SHEET LIST - SSDA			
SHEET ID	SHEET NAME	CURRENT REVISION	DATE
01 GENERAL INFORMATION			
G25-ARC-000-DRW-LA-DA0100	COVER, DRAWING LIST	C	15/05/26
G25-ARC-000-DRW-LA-DA0101	LEGENDS	C	15/05/26
G25-ARC-000-DRW-LA-DA0102	SPECIFICATION NOTES	C	15/05/26
G25-ARC-000-DRW-LA-DA0103	PLANTING SCHEDULE	C	15/05/26
02 SITE			
G25-ARC-000-DRW-LA-DA0202	SITE PLAN - PROPOSED	C	15/05/26
10 GENERAL ARRANGEMENT PLAN			
G25-ARC-000-DRW-LA-DA1201	SURFACE FINISHES PLAN - GROUND FLOOR NORTH WEST	C	15/05/26
G25-ARC-000-DRW-LA-DA1202	SURFACE FINISHES PLAN - GROUND FLOOR NORTH EAST	C	15/05/26
G25-ARC-000-DRW-LA-DA1203	SURFACE FINISHES PLAN - GROUND FLOOR SOUTH WEST	C	15/05/26
G25-ARC-000-DRW-LA-DA1204	SURFACE FINISHES PLAN - GROUND FLOOR SOUTH EAST	C	15/05/26
G25-ARC-000-DRW-LA-DA1205	SURFACE FINISHES PLAN - WINTER GARDENS (L02, L04, L06)	C	15/05/26
G25-ARC-000-DRW-LA-DA1206	SURFACE FINISHES PLAN - ROOFTOP GARDENS (L08 & L11)	C	15/05/26

UNSW G25 EDUCATION
BUILDING

University of NSW, 8 High Street, Kensington, NSW 2033

SURFACE FINISHES PLAN -
GROUND FLOOR NORTH WEST

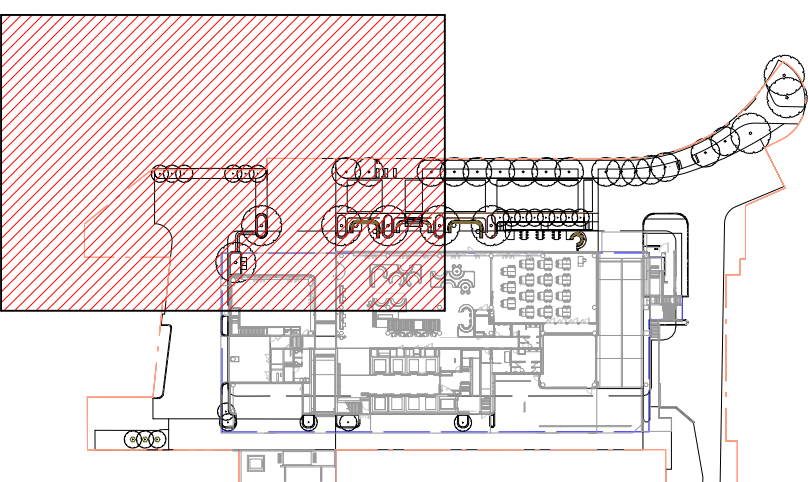
1. Swale:
 - a. Permeable boardwalk changed to concrete path
 - b. Swale profile adjusted and timber retaining wall added along 500mm southern verge

- c. Bollards relocated to suit new path alignment
 - d. Tree locations and species adjusted
 - e. Crossing points adjusted and DDA passing bays added
2. Road Pavement between G25 and SIRF changed to asphalt

3. Library Road:
 - a. Road pavement to Library Road shared zone altered to grey granite. Unit sizes adjusted as per details.
 - b. Road width adjusted to 5.9m based on PTC advice: Aconex PTC - GSCOR-000023.

- c. Granite 'bollard blocks' added to southern side of shared zone (sit within 5.9m width).
 - d. Granite rubble strips added to northern side of shared zone (sit within 5.9m width).

- e. Granite rubble strips added within shared zone.
 - f. Light poles relocated to northern side of Library Road (refer to C's documentation).
4. Stair to footpath revised to 1:20 walkway. Planting and Paving adjusted to allow accessible path of travel

5. G25 Forecourt:
 - a. Concrete seating steps / stair revised to planters with steel walls
 - b. 'Pill' planters aligned to columns and dimensions adjusted slightly to suit

- c. Furniture revised – refer new details later in pack
 - d. Paving amended
 - i. Curved paving transition changed to staggered transition
 - ii. Paver dimensions adjusted

- e. Planter adjusted to simplify kerb (possible due to revised swept paths).
7. Existing granite pavement and kerb levels adjusted – refer to civil documentation.

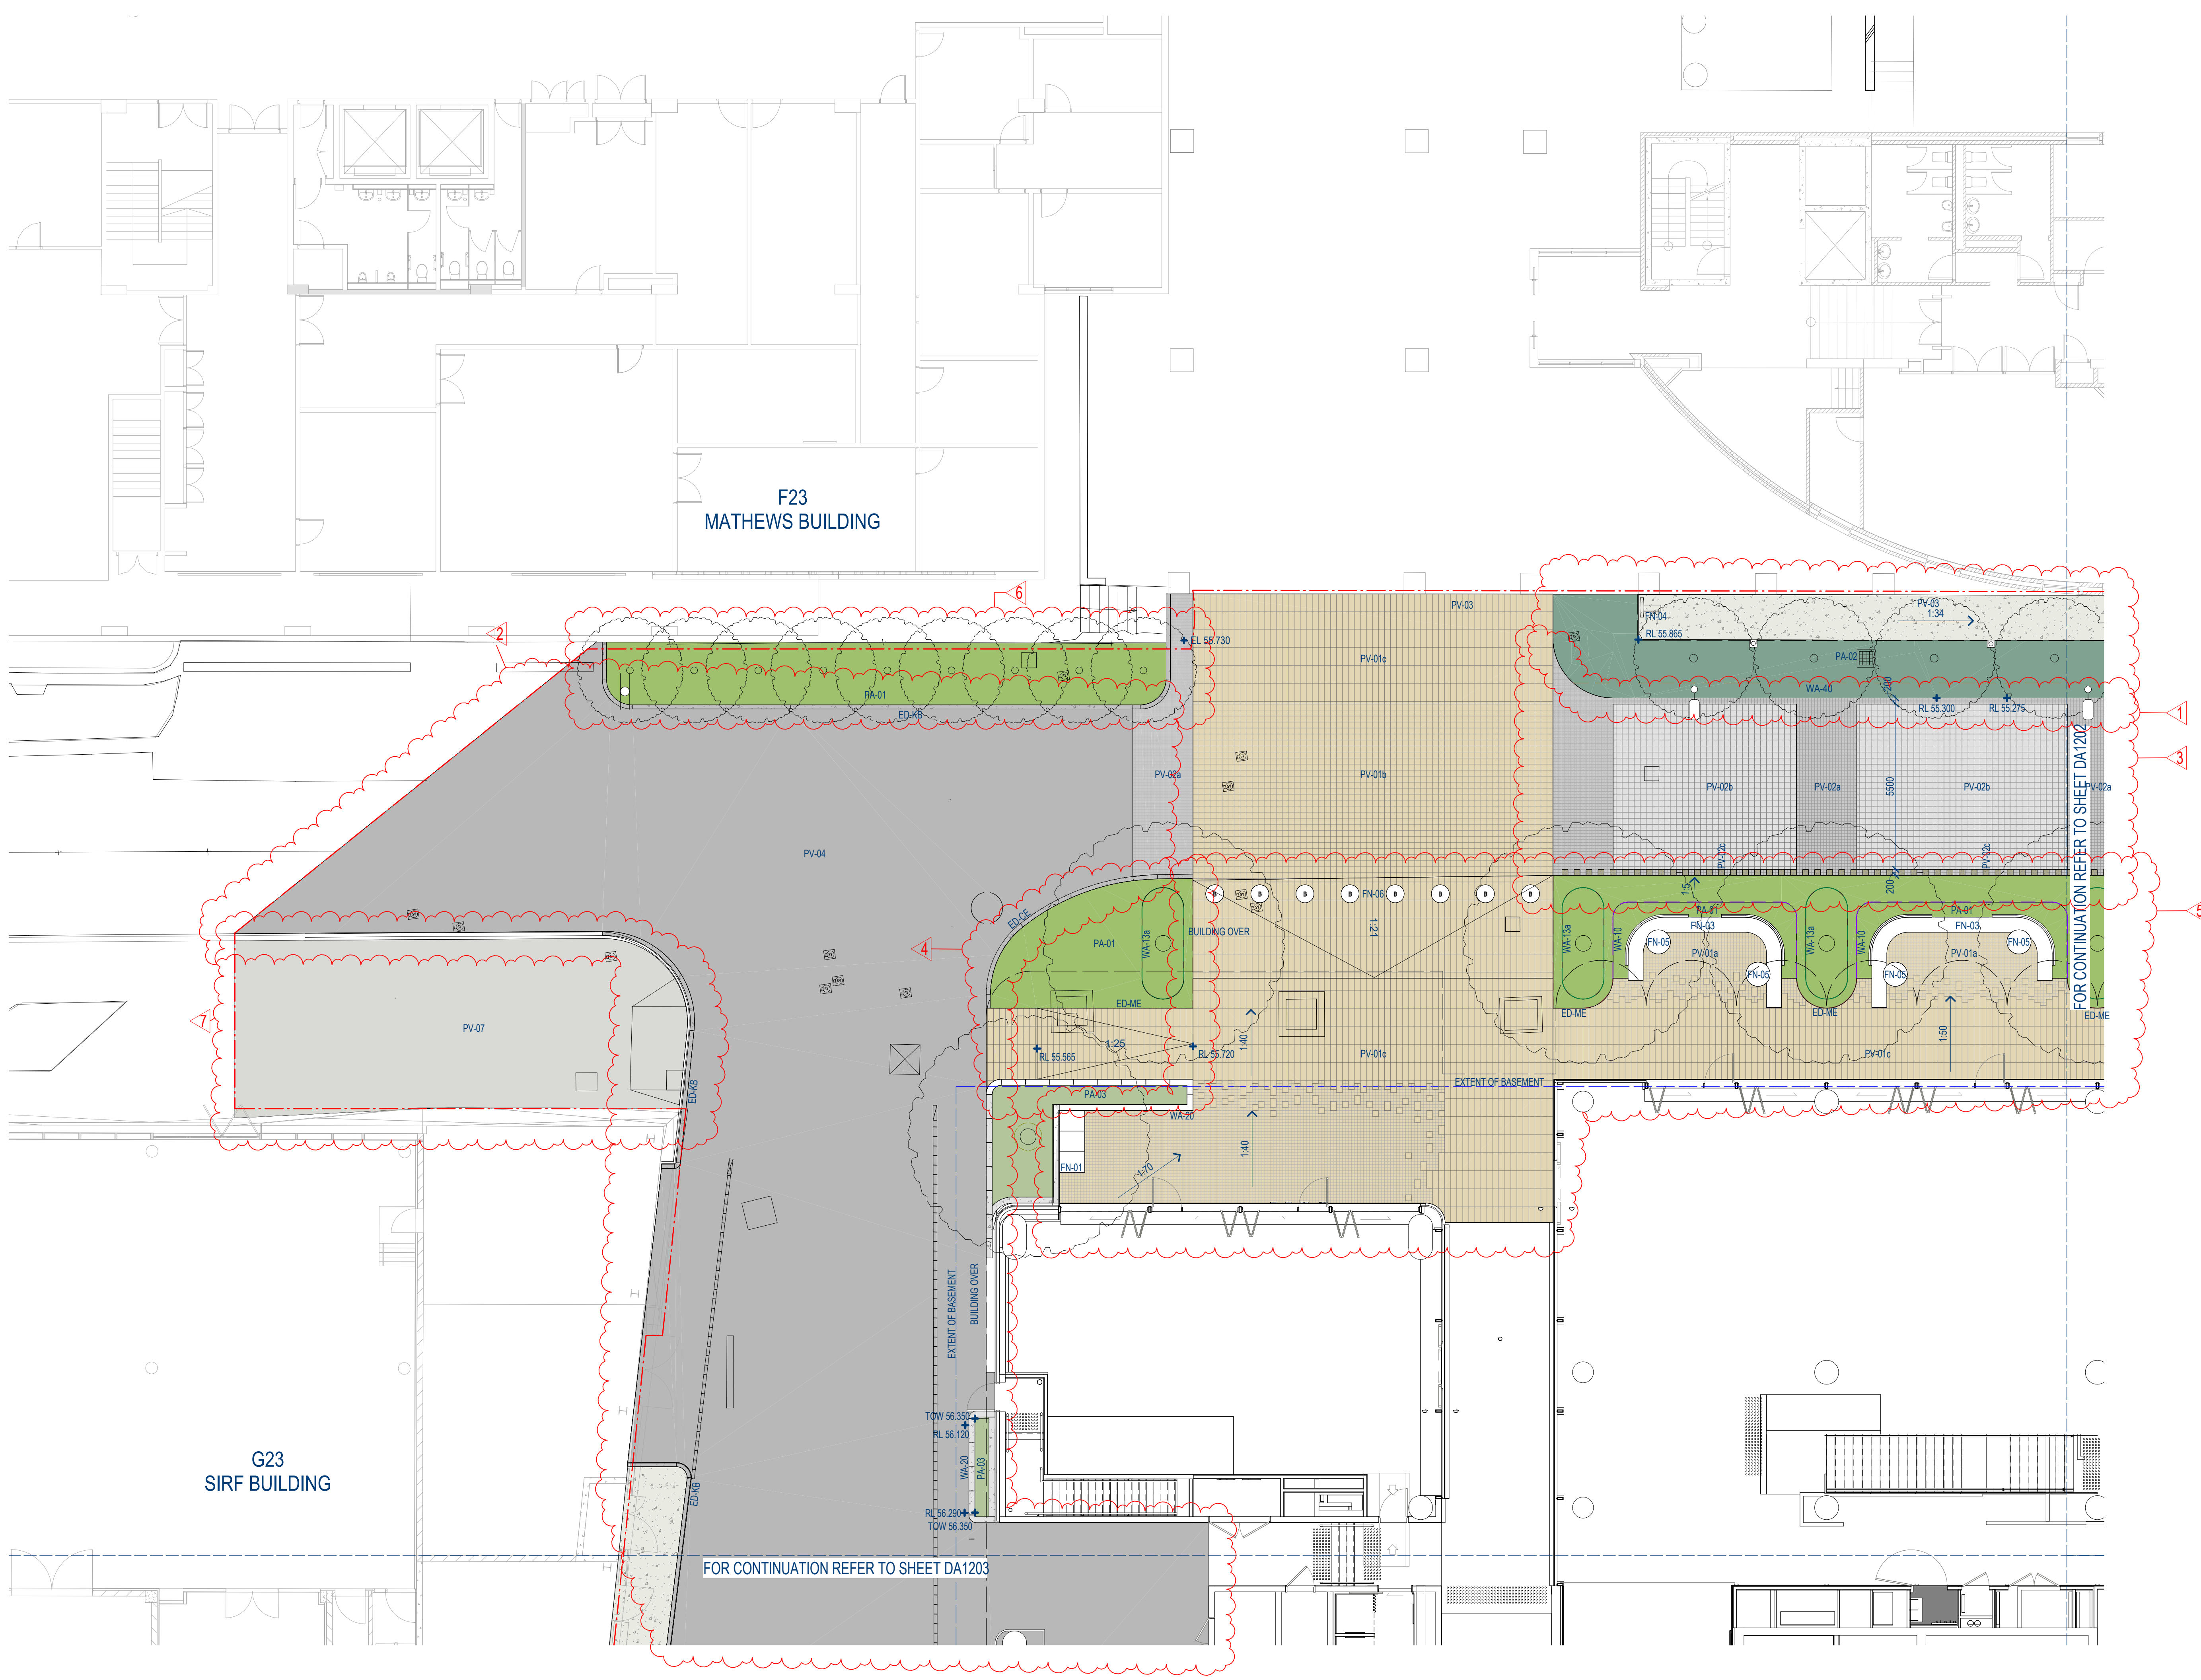
1. Swale:
 - a. Permeable boardwalk changed to concrete path
 - b. Swale profile adjusted and timber retaining wall added along 500mm northern verge
 - c. Bollards relocated to suit new path alignment

- d. Tree locations and species adjusted
 - e. Crossing points adjusted and DDA passing bays added
2. Road Pavement to ramp confirmed as asphalt
3. Library Road:

- a. Road pavement to Library Road shared zone altered to grey granite. Unit sizes adjusted as per details.
 - b. Road width adjusted to 5.9m based on PTC advice: Acornex PTC-GCOR-000023

- c. Granite 'bollard blocks' added to southern side of shared zone (sit within 5.9m width).
 - d. Granite rumble strips added to northern side of shared zone (sit within 5.9m width).

- e. Granite rumble strips added within shared zone.
 - f. Light poles relocated to northern side of Library Road (Refer LCI's documentation).
4. Footpath and landscape adjusted to accommodate fire truck hardstand

5. G25 Forecourt:
 - a. Concrete seating steps / stair revised to planters with steel walls
 - b. 'Pill' planters aligned to columns and dimensions adjusted slightly to suit

- c. Furniture revised – refer new details later in pack
 - d. Paving amended
 - i. Curved paving transition changed to staggered transition
 - ii. Paver dimensions adjusted

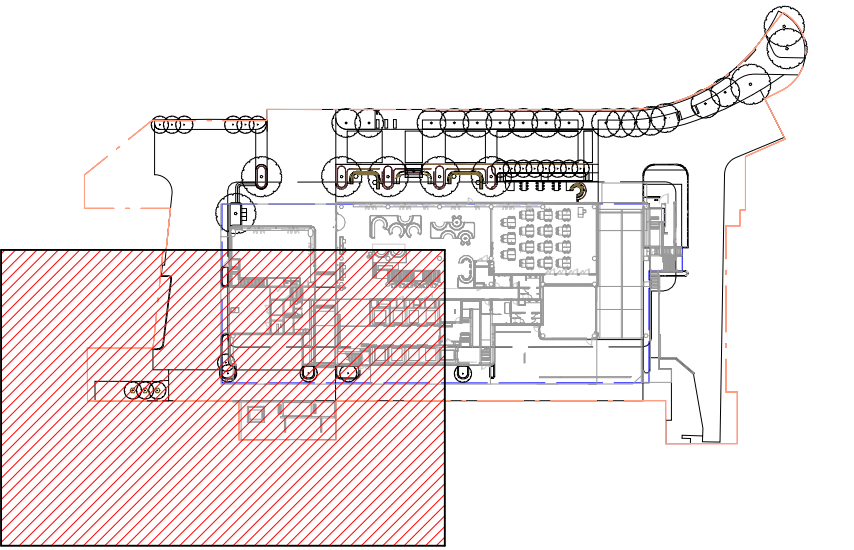
1. Road Pavement between G25 and SIRF changed to asphalt
2. Pavement adjusted to create clear / logical shared zone to back of G25
3. Concrete pavement replacement to back of SIRF not required – removed from scope

1 L08 ROOFTOP GARDEN PLAN
1 : 100

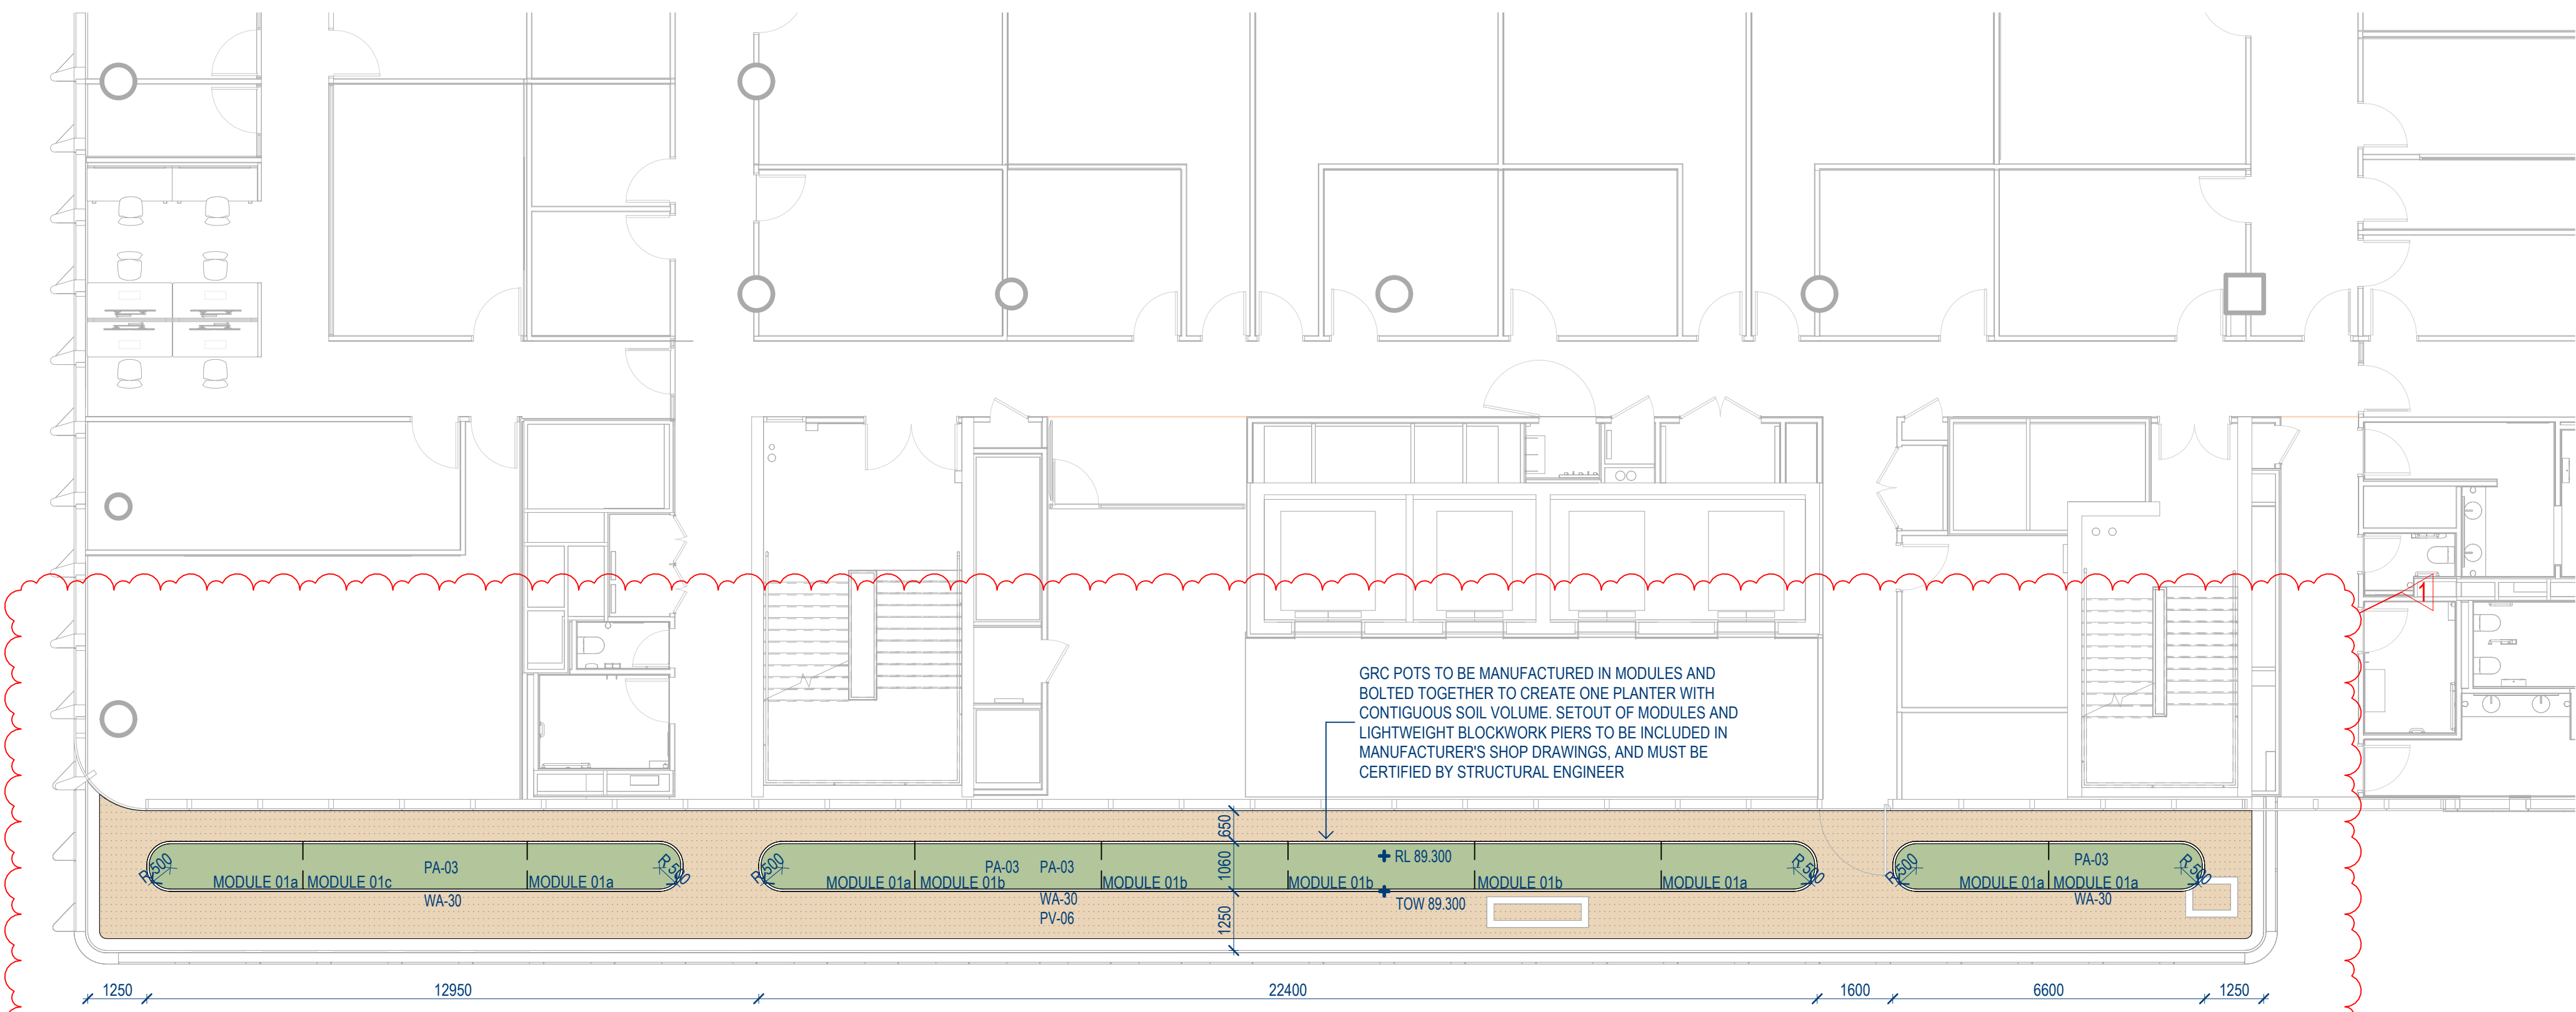
1. Rooftop Garden Revised:
 - a. GRC planter slightly re-dimensioned to allow repetitive modular design
 - b. Paving changed to pebble as maintenance path only
2. Rooftop Garden Revised:
 - a. GRC planter slightly re-dimensioned to allow repetitive modular design
 - b. Paving changed to pebble as maintenance path only

PLANTING PLAN - GROUND FLOOR SOUTH WEST

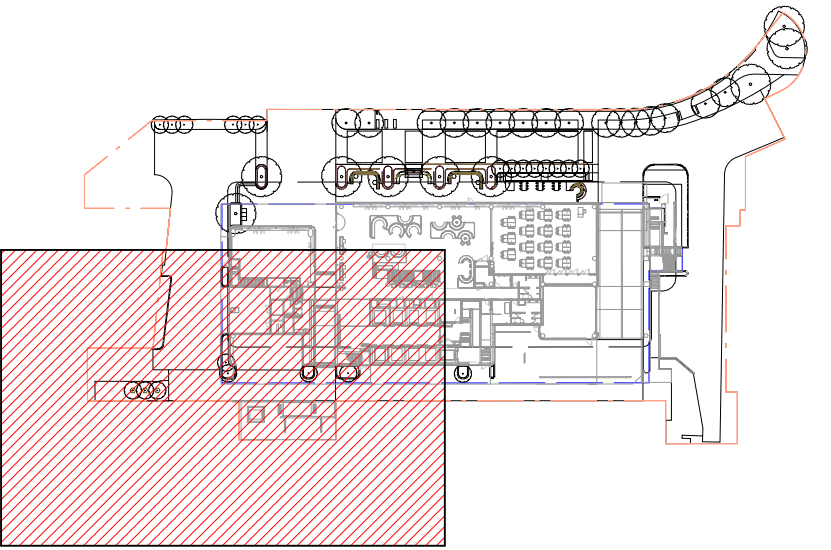
1. Planting revised with consideration of function and microclimate
